UNITED STATES PATENT AND TRADEMARK OFFICE

Office Action Summary	Application No. 10/580,138	Applicant(s) DANERI ET AL.	
	Examiner Carl D. Price	Art Unit 3749

DETAILED ACTION

A gas burner **having low emissions of polluting agents** comprising a main metal body **open at a first base end, having a housing for a gas distributor at a second base end wherein said housing has a volume inside thereof and an internal lining of a coating of refractory material,** an inner **central** lance for combustible gas **arranged inside said main metal body,** at least two outer side lances for combustible gas associated with said main metal body, a single duct for the **introduction** of pre-heated air **where said single duct is connected to a side surface of said main metal body,** a regulation system for the combustible **gas,** a refractory unit **associated with said first base end,** characterized in that said gas burner comprises a series of nozzles **situated in said refractory unit** for the injection of the pre-heated air into **a combustion chamber of an oven, said series of nozzles being in communication with a plenum defined by the volume inside said housing that is internally lined

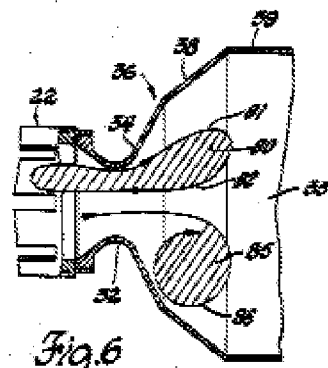
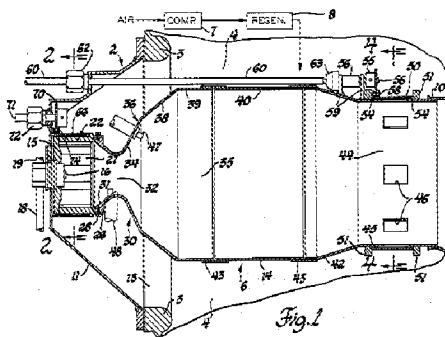
In regard to **claim 1**, **US 3418062 (Hovis et al)** shows and discloses a gas burner capable of a gas burner having low emissions of polluting agents (11 or 124; figures 8-11) comprising:

- a main metal body (68'; fig. 8) **open at a first base end (84')**;
- **a housing (114) for a gas distributor (88', 90) at a second base end**
 - o **wherein said housing has a volume inside thereof and an internal lining of a coating of refractory material (82'; "...the inward protruding end of the inner port block 82' the annular fuel conduit 114 is extending thereover ...")**;

- an inner **central** lance (92') for combustible gas (see; "GAS"; fig. 8) **arranged inside said main metal body (68')**;
- at least two outer side lances (116; "gas flow grooves") for combustible gas associated with said main metal body (i.e.- Note that the gas lances (116, grooves) are located radially outward of the central lance, and as such are understood to be "outer side" lances. That is, with respect to the inner central lance. Also, the fuel being fed to the gas lances (116, grooves) is supplied thereto by conduit 112 passing through the main metal body (68'), and as such the lances are understood to be for combustible gas *associated with said main metal body.*)

- a single duct (fed by valve 104; figure 8, or duct 132, 138; figure 10) for the **introduction** of air (Note that since the laterally placed air duct merely labeling the duct as "single" is not sufficient in itself to preclude the presence of other air duct. And, as the duct is formed as a single passage, it is therefore understood as a "single duct") **where said single duct is connected to a side surface of said main metal body;**

- a regulation system (106', 120) for the combustible **gas**;
- a refractory unit (78') **associated with said first base end**, characterized in that said gas burner comprises a series of nozzles (80') **situated in said refractory unit** for the injection of the air into **a combustion chamber of an oven (10, 10A; Note that the chamber 10, 10A of US 3418062 (Hovis et al) is disclosed as a "soaking pit" and "soaking pits are widely used throughout the steel industry for heating ingots of steel to rolling or forging temperature."** Since ovens perform the same function of heating articles placed therein the soaking pit of US 3418062 (Hovis et al) is patentably indistinguishable from applicant's only broadly claimed oven);

- **said series of nozzles (80') are in communication with a plenum (94', fig. 8; or 128, fig. 10) defined by the volume inside said housing and is located between the inner central lance and the outer side lances;** and

- said gas regulation system comprises means for varying the distribution percentage of the combustible gas between the inner central lance and the outer side lances thereby, switching between functioning modes.

US 3418062 (Hovis et al) shows and discloses the invention substantially as set forth in the claims with possible exception to:

- means introducing pre-heated air;

US 5570679 (Wunning) shows:

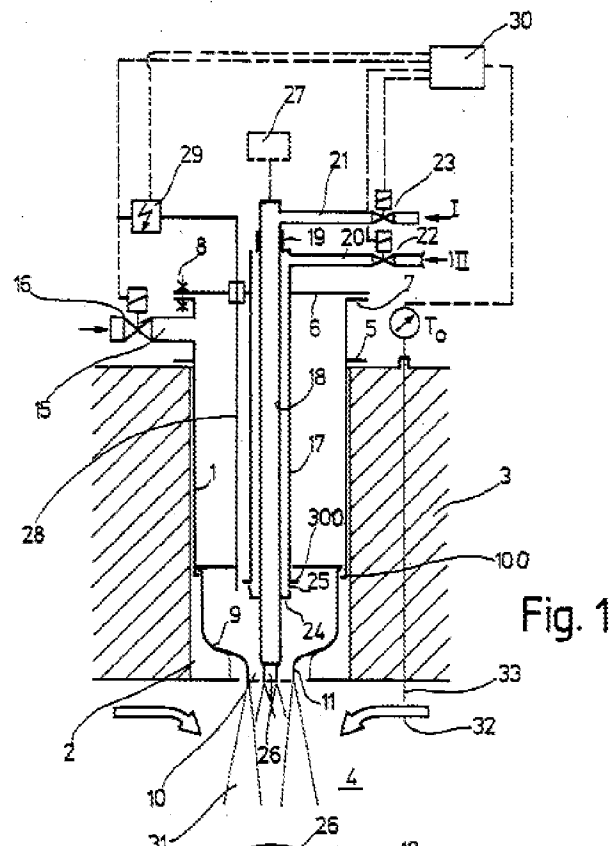
US 5570679 (Wunning) teaches, from applicant's same multi-mode flame and flameless burner field of endeavor, teaches, from applicant's same multi-mode flame and flameless burner field of endeavor, means introducing pre-heated air (15) and wherein when operating on the gas regulation system (22, 23, 30), it is possible to continuously switch from a flame functioning mode of the burner to a flameless functioning mode (i. e. - "an essentially flame-- and pulsation-free reaction"), the latter characterized by low emissions of polluting agents.

(4) A **lateral air supply stub 15** is connected to the jacket tube 1 outside the furnace wall 3; a combustion air valve 16 is located in this stub 15, and **optionally preheated combustion air** can be supplied by way of the stub 15. The combustion air supply stub 15, together with the jacket tube 1 and the combustion air valve 16, forms the air supply device, which as seen from the drawing is shaped such that all the combustion air supplied acts upon the combustion chamber 9 and emerges from the outlet opening 10 thereof. (Highlighting and Underlining Added)

(15) As soon as the **furnace chamber 4 has been heated to the ignition temperature of the fuel** assigned to the outer fuel lance 17, which is ascertained by a temperature sensor 33 protruding into the furnace chamber 4, **the control unit 30 switches the burner over to a second operating state**; to do so, it closes the first fuel valve 22 and opens the second fuel valve 23. **This switchover may be done in stages or continuously.** (Highlighting and Underlining Added)

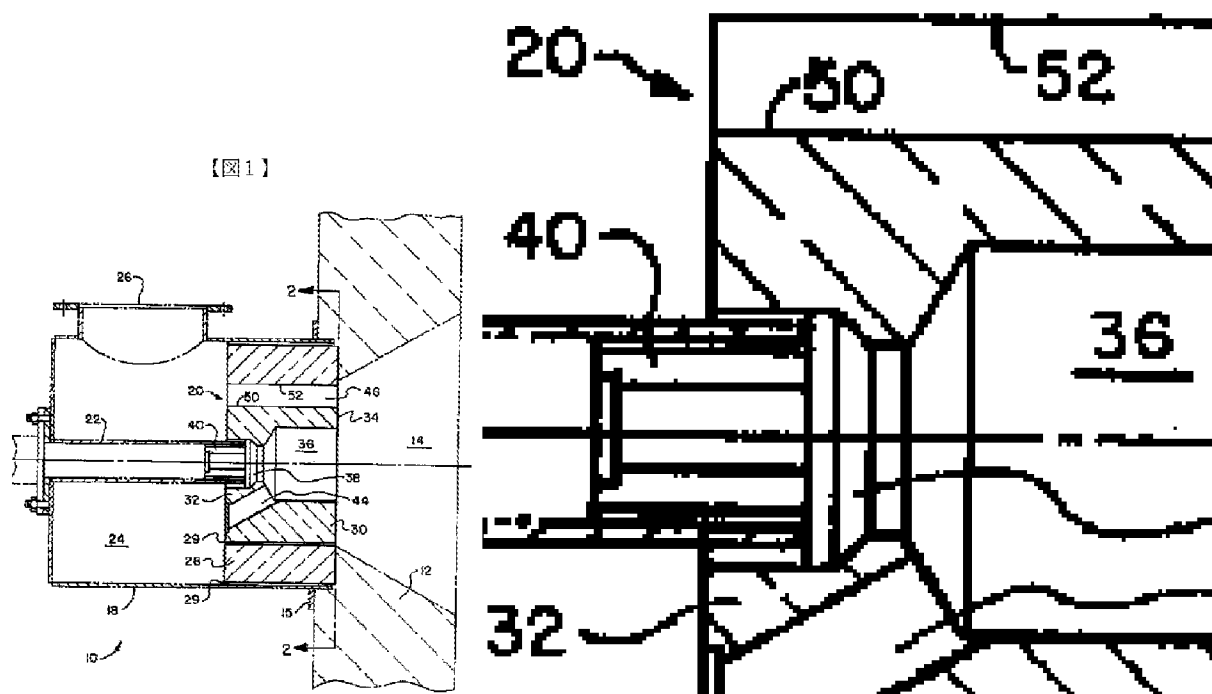
JP 07-190319 teaches, from applicant same central lance type burner field of endeavor, shows a refractory unit (20) with a free annular crown (i.e. – the free space about the distal end of lance) and being defined between the inner surface of said central hole (generally 38) and the external diameter of said tip portion (the distal end located within the refractory body recess) of the inner central lance, said free annular crown being in communication with said plenum (24) thereby allowing the passage of a sufficient quantity of air there around, which would necessarily act to cool the tip of inner central lance.

Fig. 9

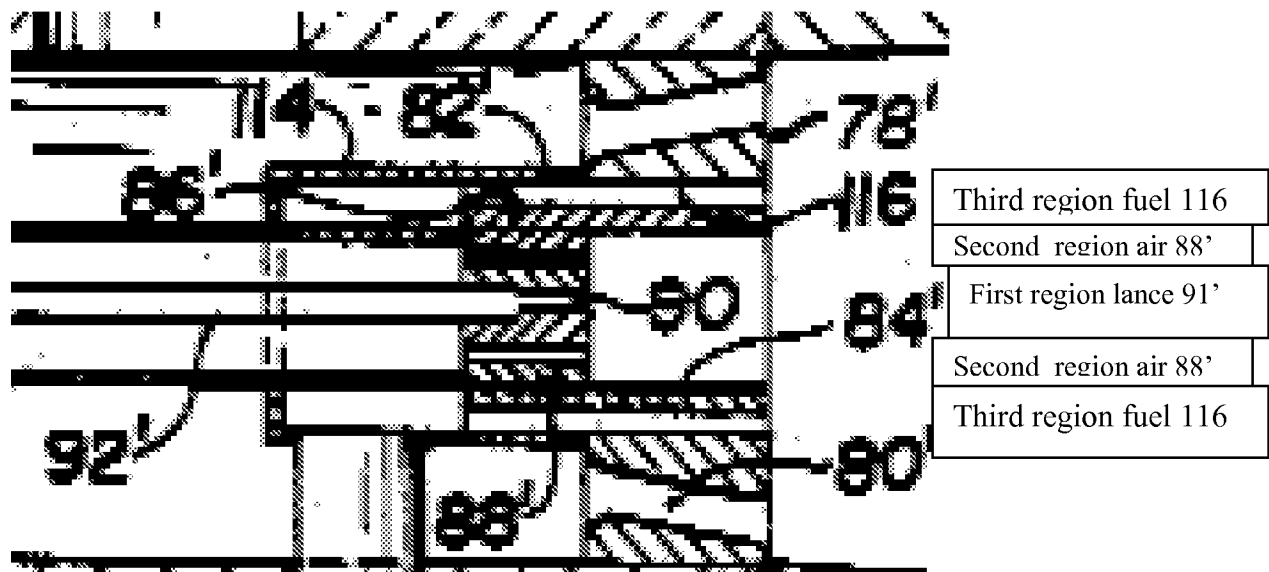
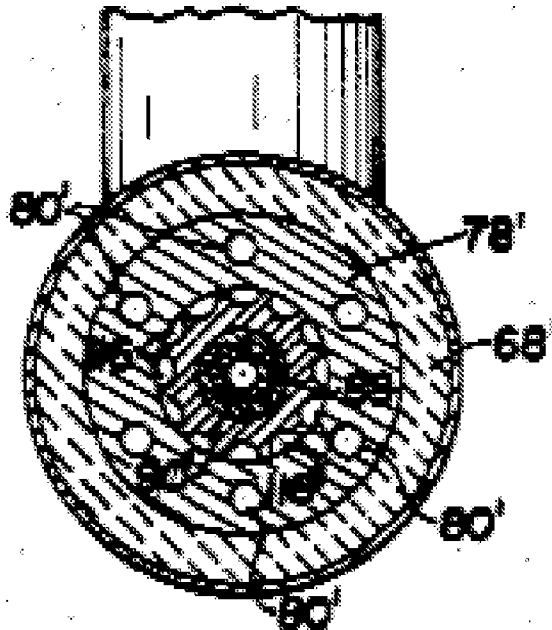
In regard to **claim 3**, **US 3418062 (Hovis et al)** shows (see the annotated figures herein below) nozzles (88') for the air housed in the second region.

In regard to **claim 5**, **US 3418062 (Hovis et al)** shows the first region comprising a cavity (84') communicating with the combustion chamber (76') and into which the air from the series of calibrated holes (88') flows together with the combustible gas injected through the inner lance.

In regard to **claims 7, 8 and 10**, **US 3418062 (Hovis et al)** shows the nozzles of said series of nozzles situated at an equal distance along a coaxial circumference with the inner lance (90', 92') and lying on a base surface of the second region (see the annotated figures herein below).

Fig. 11

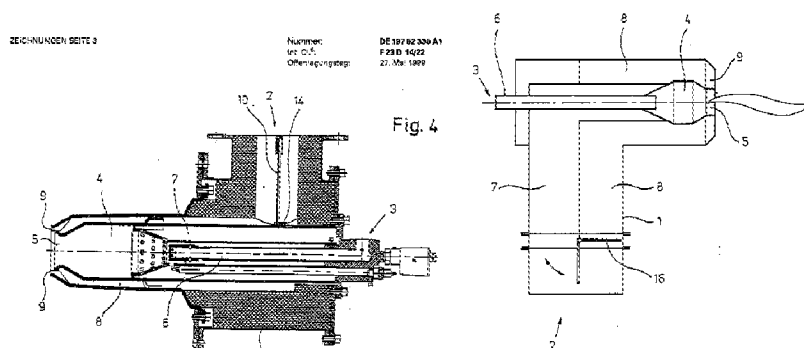
See **DE 19752335 A1** which discloses air-inlet (2) for pre-heatable combustion air:
